Oil jetties at the Port of Hull

W. J. Leaman, B.Sc., A.M.I.C.E.

R. K. Postlethwaite, B.Sc., A.M.I.C.E.

FIG. 13: VERTICAL PILE

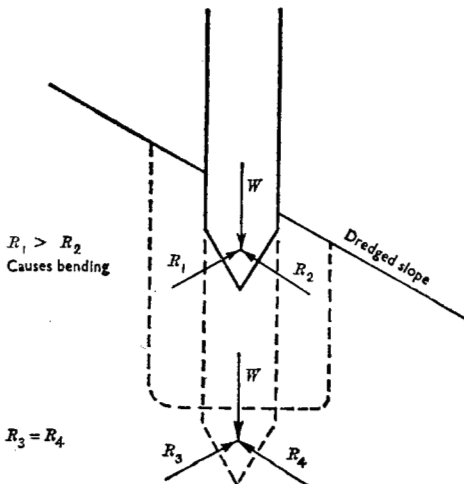
107. The first time he had encountered this difficulty was when driving 10-ton precast piles in a bank. When a 5-ton hammer was used on them, the piles cracked. They entered the ground, but there was less resistance on one side than on the other. When held in guides above the ground, the piles cracked. The difficulty was overcome by having a level seating of some depth in the bank into which the pile was pitched (Fig. 13).

FIG. 14: RAKING PILE

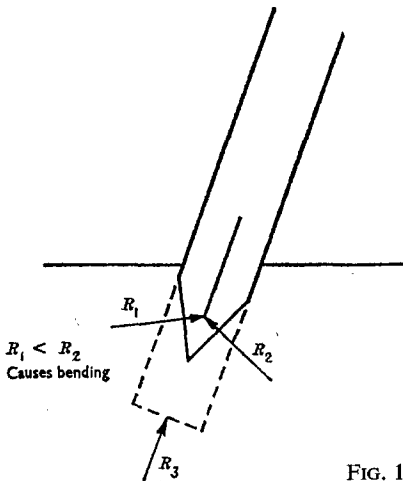
108. There was a similar position in the present instance. The pile was driven on a rake. When the pile was driven vertically, there were forces normal to the sides of the toe. As soon as a raking pile was used (Fig. 14), the reaction at one side must be higher than at the other. As soon as this occurred, there would be a bending force in the pile which cracked it.

109. There were two possible answers. One was to have special shoes made which were calculated out to the right angle, but this could be difficult. Probably the real answer was to have a flat bottom to the pile.

148. In reply to Mr Boyce, § 134, a typical driving record for one of the cracked reinforced concrete piles would show a total penetration of about 40 ft, the first 20 ft of which would have been achieved by the pile settling under its own weight and the weight of the hammer; followed by a further penetration of about 15 ft at very light driving, before hardening up in the final 5 ft to reach the required 'set' on the boulder clay. Those which cracked were at the shore end where the bed level was high. Only hair cracks had been seen, and it was therefore considered unnecessary to extract any of the piles. Subsequent examinations had shown that the pressure from the superstructure had caused cracks to close and there were no signs of deterioration.

149. Mr Roberts had asked whether the Rendhex piles driven with a flat end or an open end showed any inclination to divert when driven in a rake. Those driven with a flat end were in the approach jetty where the rake was very steep, and no tendency to wander had in fact been observed. However, in several cases it was noticed that open ended piles driven at a rake of 1:3 tended to curve in the manner suggested by Mr Roberts in § 108. This was first noticed when a lantern which had been lowered into a pile to investigate a leaking seam weld showed the pile to be deflected by 18 in. at a depth of about 70 ft below its head.

FIG. 15: NO. 3 JETTY HEAD—CROSS SECTION

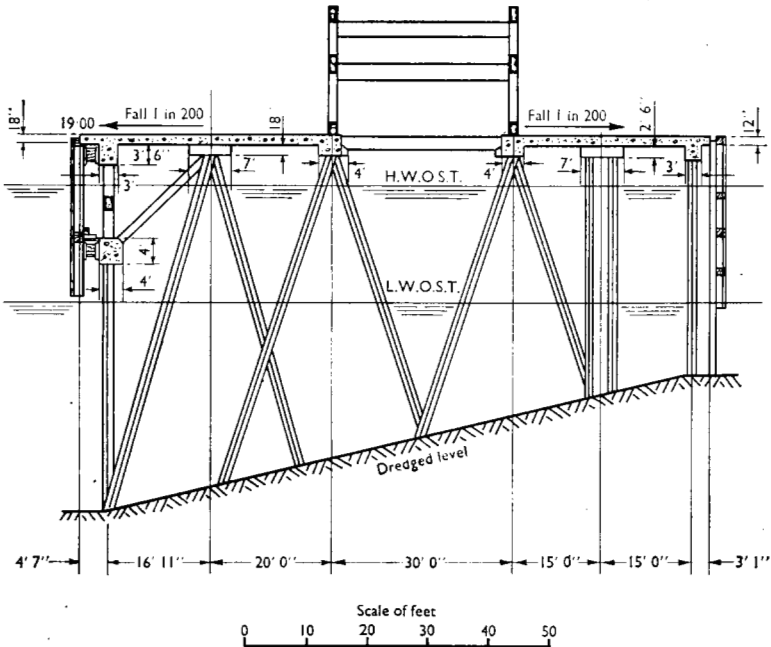
135. It would be helpful if a cross section of No. 3 jetty head could be provided because it was difficult to see how the loads from the lower waling beam were taken through the structure to the ground.

169. The cross section of No. 3 jetty head (Fig. 15) had been supplied by the Authors in response to the request from Mr Boyce in § 135.
